SRM RUNWAY 12-30 FINAL REPORT

ALBUQUERQUE INTERNATIONAL SUNPORT (ABQ)

HOT SPOT #1 MITIGATION

Safety Risk Management Panel Meeting

Figure 2- Alternative 1A.

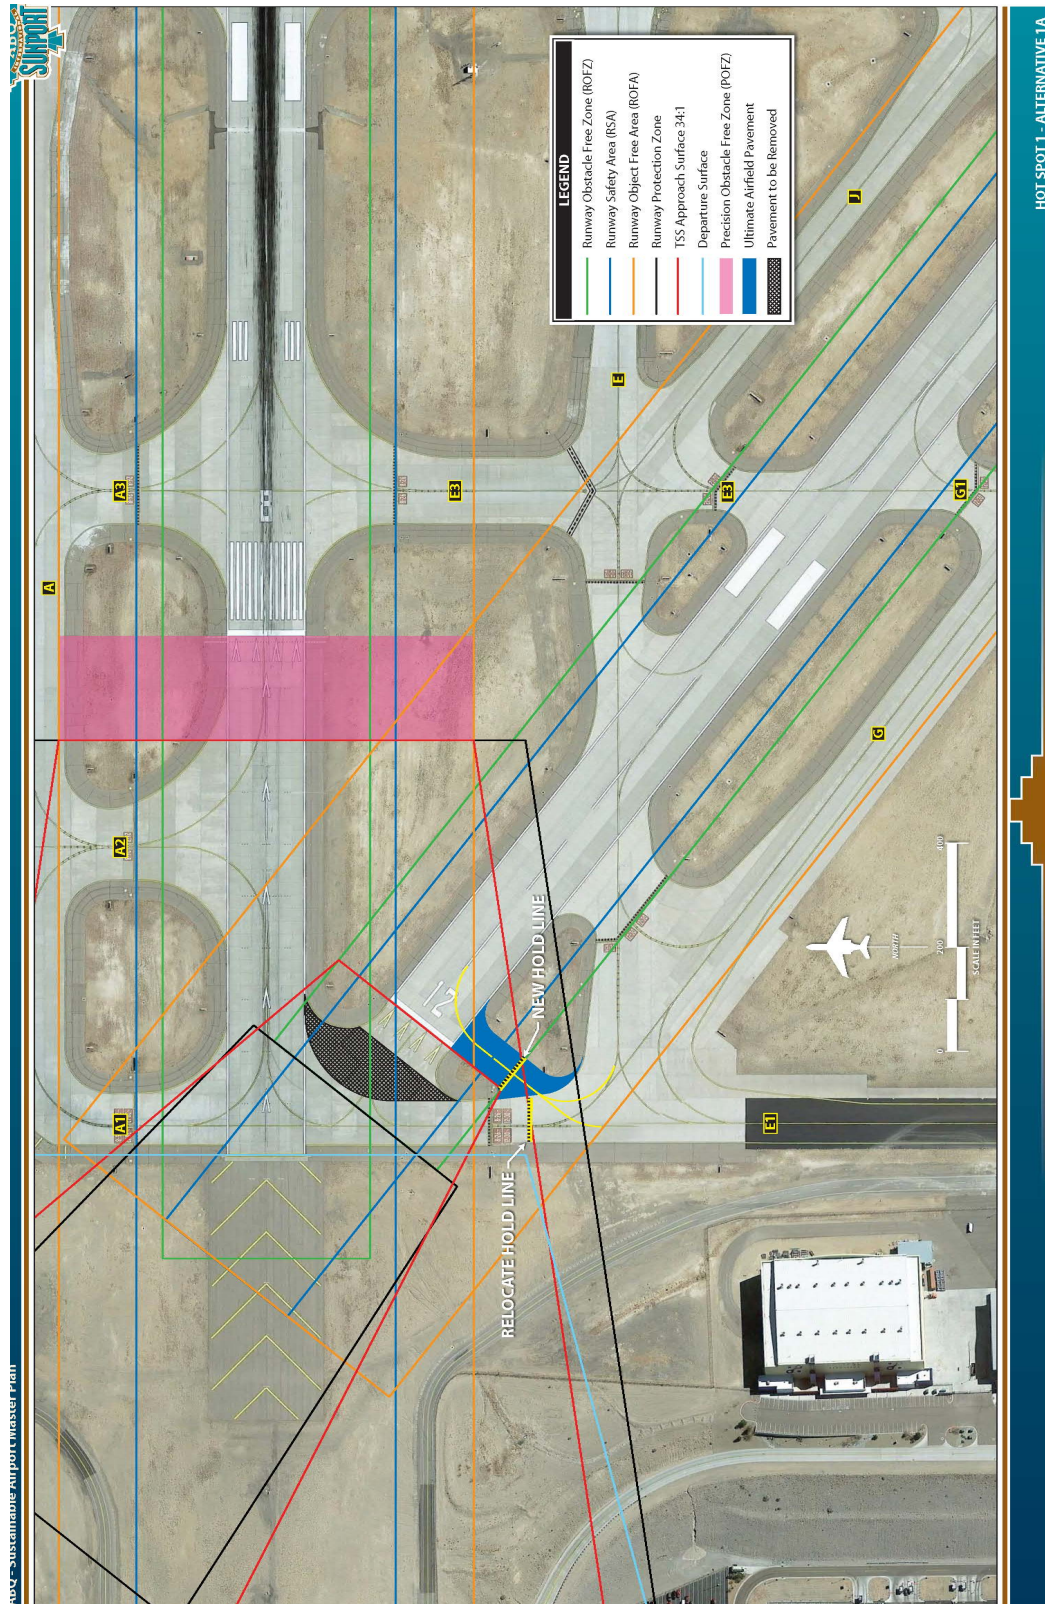
Alternative **1A** (Figure 2) essentially removes a section of pavement beyond the threshold and replaces it with a short 90 degree entrance taxiway leading to the threshold. Although this option would successfully decouple the runways, the new taxiway would intersect with and complicate the existing intersection with Taxiways E1, E, and G. One of the objectives of the FAA RIM program is to eliminate confusing airfield geometry such as taxiway intersections with more than 3 nodes. This alternative would result in a taxiway with 4 nodes. The panel believes that any risk reduction associated with pavement removal beyond the runway threshold would be more than offset by the confusing taxiway intersection.

During the initial presentation of alternatives, some panel members suggested that Alternative 1A could be improved if the new entrance taxiway at the end of the runway was eliminated. This modification would eliminate the complex intersection previously identified for Alternative 1A. The panel decided to consider this change as a parking lot item at the conclusion of the panel deliberations. This modification would use Taxiway E as the primary entrance taxiway for aircraft departing on Runway 12 (See Figure 2). It would require aircraft to back-taxi about 350 ft. to use the full length of the runway for departures. Back taxi operations might be rare since Runway 12 is lightly used for departures. It would take advantage of the existing Taxiway E intersection as a “high speed” exit. It would also simplify taxiway signage in the area. However, the panel identified safety concerns that would offset these advantages:

- The time required to back taxi would increase the risk of a conflict with other aircraft arriving on Runway 12 as well as Runway 08
- It is not a standard airport configuration. Parallel taxiways normally provide an entrance at the end of the runway
- Back taxi operations are not commonly used at ABQ

In the end, the panel believes that this is not a viable option because any improvements to the operation would be offset by new hazards and risks.

Figure 3- Alternative 1B.

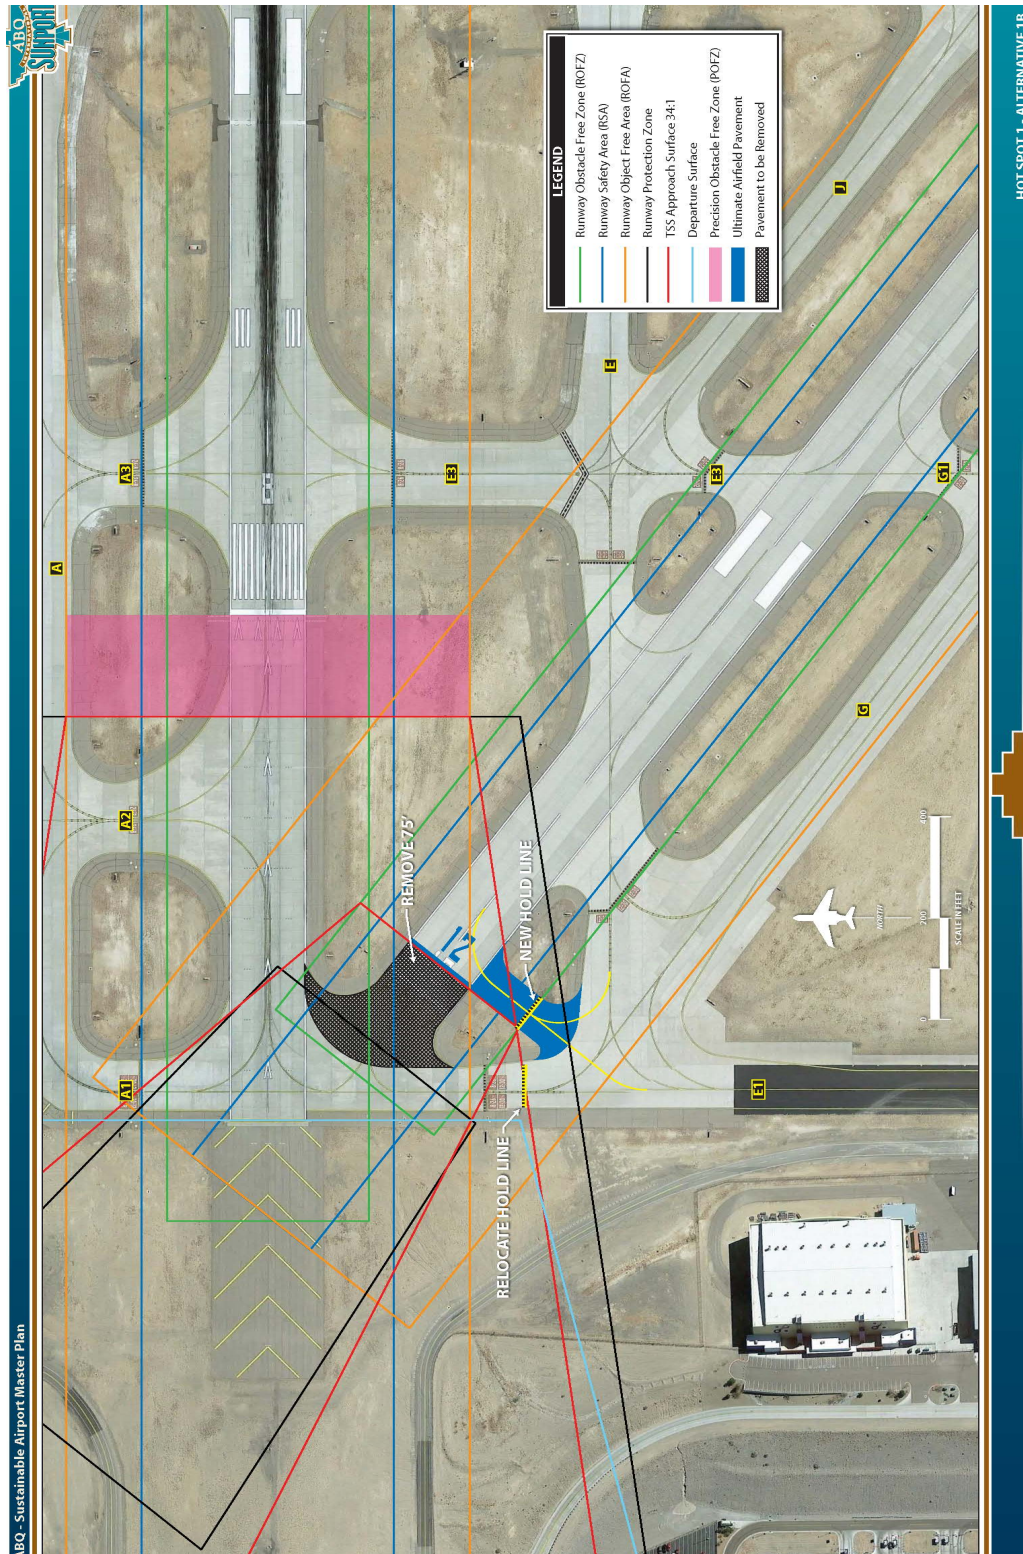
This hazard only applies to Alternative 1B (Figure 3). The panel identified three causes for this hazard related to the new intersection created by four separate taxiways: E1, E, G, and the new entrance taxiway: (1) Introduction of an additional taxiway node; (2) Wide pavement in the taxiway intersection, and (3) Non-standard placement of signs caused by the wide intersection

FAA Advisory Circular 150/5300-13A, Airport Design, recommends a standard taxiway intersection that complies with the “three-node” concept, meaning that a pilot is presented with no more than three choices at intersections- left, right, and straight ahead. This arrangement keeps taxiway intersections simple and allows for proper placement of airfield markings, signage and lighting. This hazard adds a fourth node to the intersection.

Assessment: This hazard cause could lead to a loss of situational awareness for pilots who might cross the wrong runway and contribute to a runway incursion. However, the panel believes that the likelihood of a runway incursion is reduced compared to the existing configuration because the new taxiway would be the only way to access the runway 12 threshold. Therefore the final risk level is judged to be **Low**. If this alternative is selected, in pavement taxiway signs would be needed to provide pilots with positive feedback. The panel also believes that the conversion of Taxiway E1 south of Taxiway G to a non-movement area ramp would eliminate the fourth node and thereby eliminate this hazard altogether.

This hazard only applies to Alternative 1B as shown in Figure 3. There does not appear to be enough wingtip clearance for aircraft that are holding at the relocated hold line for Runway 08 and the new hold line for the Runway 12 threshold taxiway. For example, an aircraft holding for a Runway 12 departure might create a hazard for aircraft using the new threshold taxiway for a runway 12 departure. The same might be true if an aircraft is holding for a Runway 8 departure while another is approaching the Runway 08 hold line.

Assessment: Although wingtip strikes are not credible, increased controller workload could introduce a **Minimal** severity for this hazard. The panel identified airport design standards as a control that would eliminate this hazard and is recommending that the design fully comply with proper clearances. The resulting risk for this hazard is **Low**.

Figure 4- Alternative 1C.

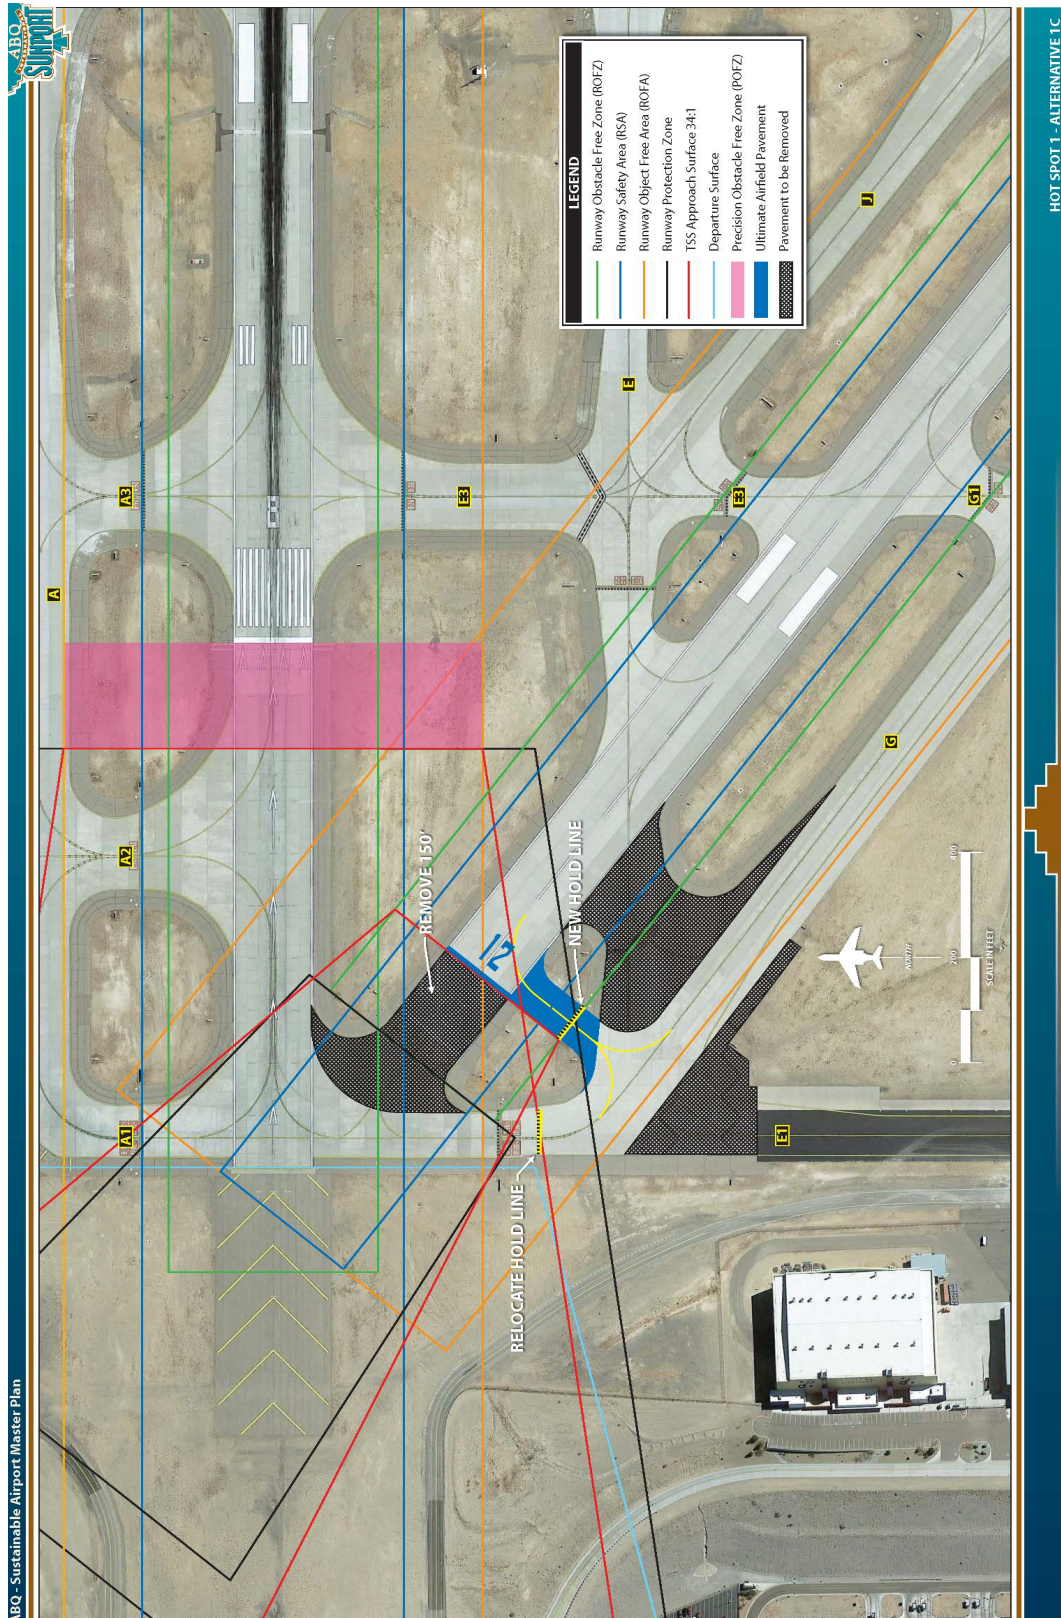
Alternative 1C is the only alternative that proposes a closure to Taxiway E1. It would eliminate one of two access routes to and from the runways at ABQ. However, the closure of Taxiway E1 can be applied to any of the remaining alternatives and the resulting hazards and risks would remain the same. The panel identified two causes of this hazard:

ABQ-107-4a. Closing of Taxiway E1 for access to Runway 08 and 12

Assessment: Taxiways E1 and K comprise the key access routes for aircraft in the Cutter Aviation ramp area. This is a busy ramp and Taxiway K is often blocked by large aircraft maneuvering in this area. Currently, aircraft needing access to the runways during these periods can use either Taxiway E1 to the west or Taxiway K to the east. If E1 is unavailable and Taxiway K is blocked, aircraft will be forced to taxi around the blocking aircraft or be faced with an unplanned delay. The result would be increased airfield congestion, increased controller workload, and airfield delays. The panel rated this hazard severity as **Minor** and the likelihood as **Frequent** based on the amount of traffic handled by Cutter Aviation. The resulting risk level is **Medium**. The panel identified conversion of Taxiway E1 to a non-movement area and retaining the access to taxiways E, G, and A1 as the only mitigation that would reduce risk. Converting Taxiway E1 to non-movement would simplify taxi instructions and thereby lower the risk of a runway incursion in this area.

Alternatives 1C and 2 (Figures 4 and 5) eliminate the western most portion of Taxiway E. Taxiway E is a full parallel taxiway for Runway 08-24. It provides a standard taxiway configuration that facilitates the east-west movement of aircraft. This hazard applies to both Alternative 1C and Alternative 2.

Assessment: Aircraft routinely need navigate one end of Runway 08/26 to the other in the event of a change in landing operations and to accommodate other operational needs. Aircraft holding on Taxiway A1 (Figure 3) can be instructed to cross the approach of Runway 08 and then turn left on Taxiway E to proceed to the east end of the runway. With the western section of Taxiway E no longer available, taxiway instruction become much more complicated. This change would increase controller workload, increase taxiway congestion, contribute to a loss of situational awareness for pilots, and increase the likelihood of runway incursions. Runway incursions are a credible outcome for this hazard, so the panel rated the severity as **Major**. The resulting risk level is **Medium** as documented by the HAW. The panel identified the restoration of the full parallel taxiway for Alternative 1C as the only

feasible mitigation measure. However, this mitigation is not feasible for Alternative 2 because of conflicts with the Runway 12 threshold.

Figure 5- Alternative 2.

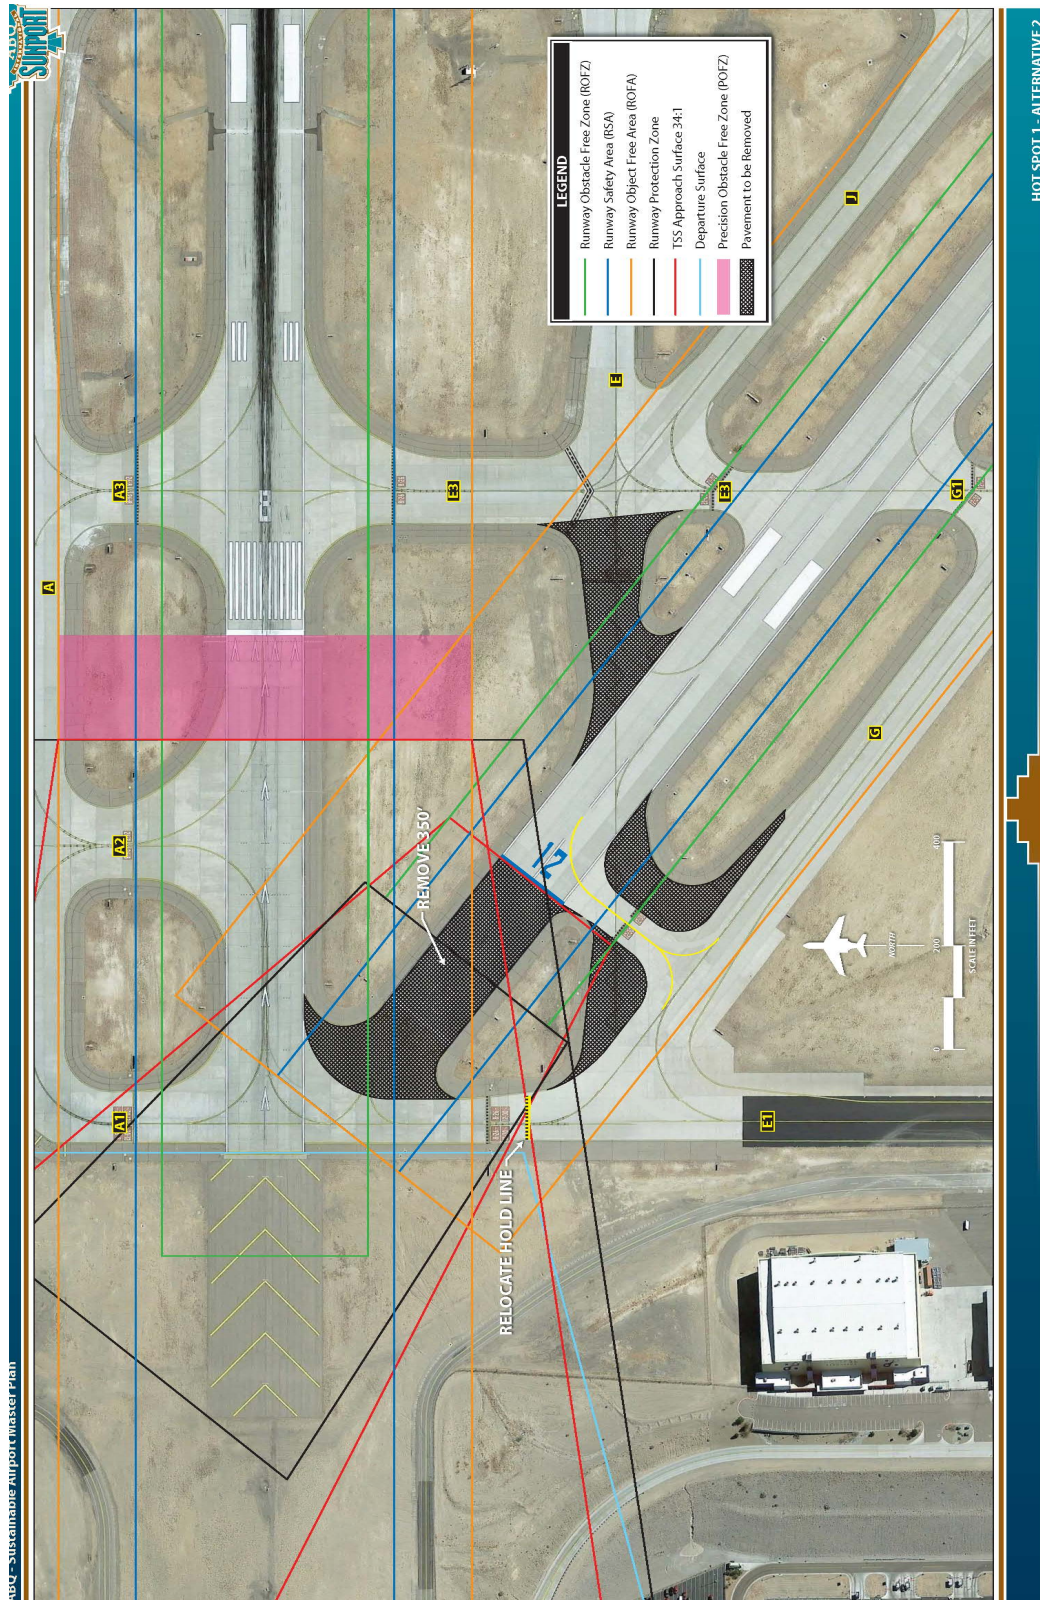
outcome increases as runway length is shortened and fewer aircraft use Runway 30. Using this criteria, the panel judged the likelihood for Alternatives 1B and 1C to be Remote, but assigned an increased likelihood of **Probable** for Alternative 2. Therefore, Alternatives 1B and 1C have a risk level of Low and Alternative 2 has a risk level of **Medium**. Although the panel recommends pilot briefings and runway length signs for all three alternatives, it does not believe the risk level for Alternative 2 can be lowered below **Medium**. Therefore, the panel does not recommend implementation of Alternative 2.

As shown in Figure 5, the relocation of the Runway 12 threshold by 350 ft (Alternative 2) places the existing hold line on Taxiway A1 inside the threshold siting surface for Runway 12. This situation violates current airport design surfaces and requires the relocation of the hold position further from the Runway 08 threshold (towards the terminal). The planning team will develop a configuration that addresses this issue if Alternative 2 is selected. Therefore, the panel did not complete the risk assessment for this hazard.

Figure 6- Alternative 3.

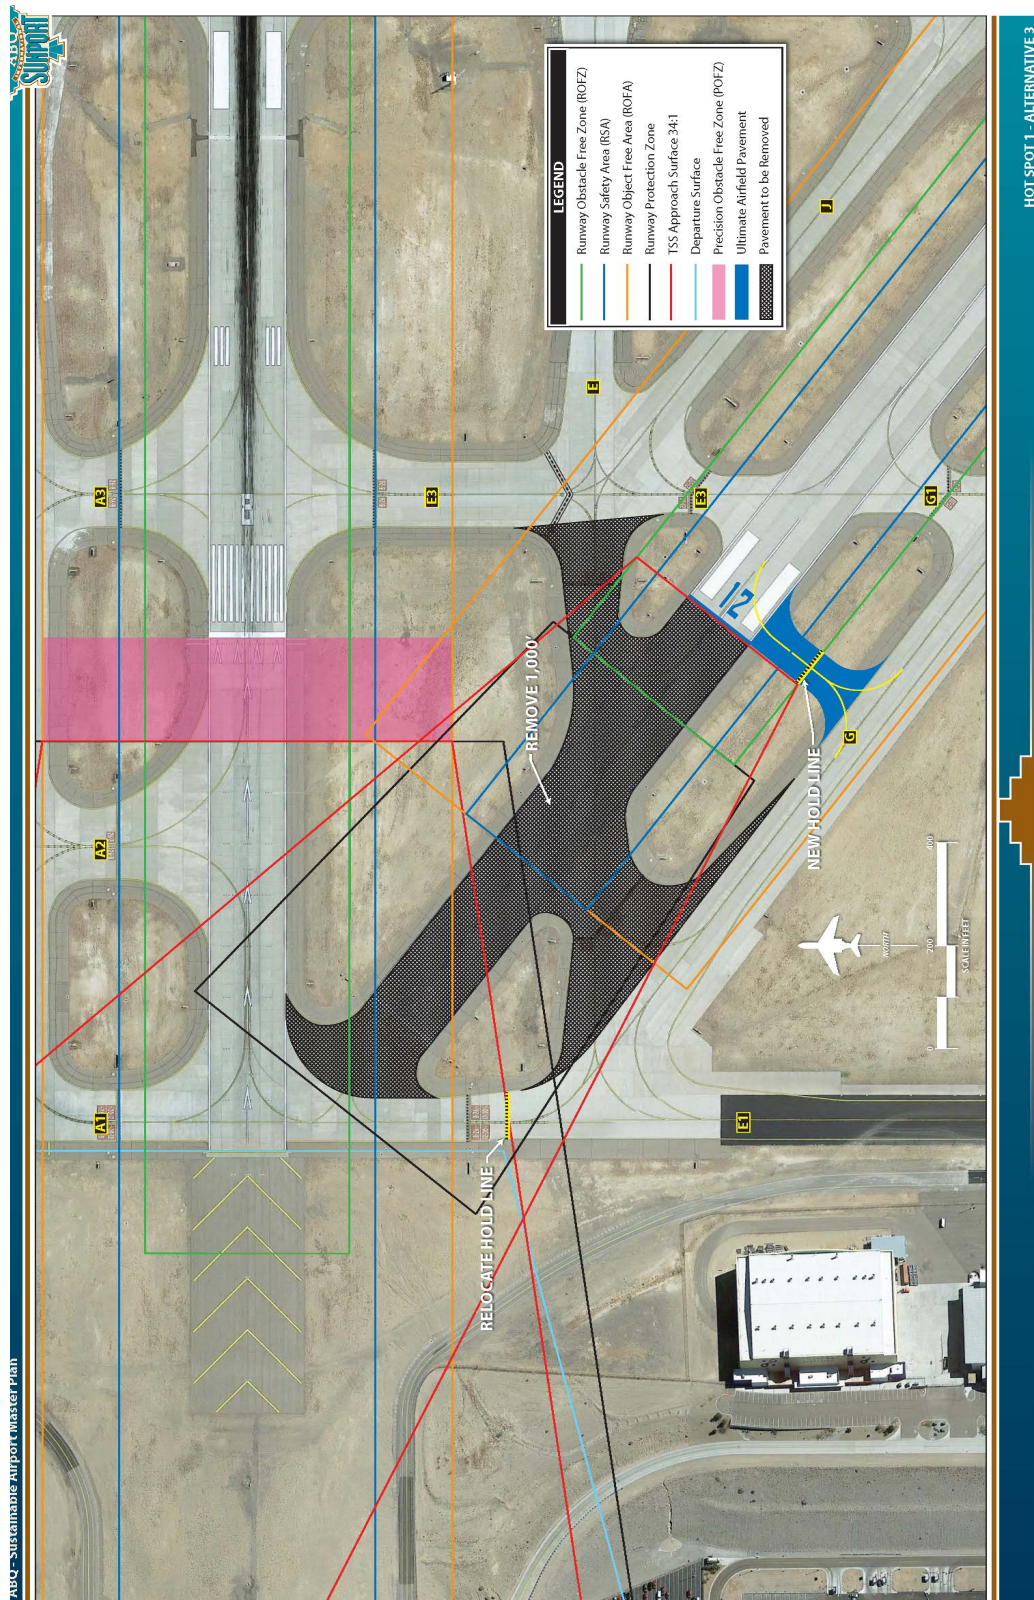
Alternative **3** retains all of the hazards identified for alternative **2** while failing to provide minimum runway length requirements for the majority of general aviation aircraft. (Paragraph 4 provides a discussion of length requirements for runway 12/30.) In addition, a shortened runway might lead to increased use of the main runways that could introduce new hazards into the system.
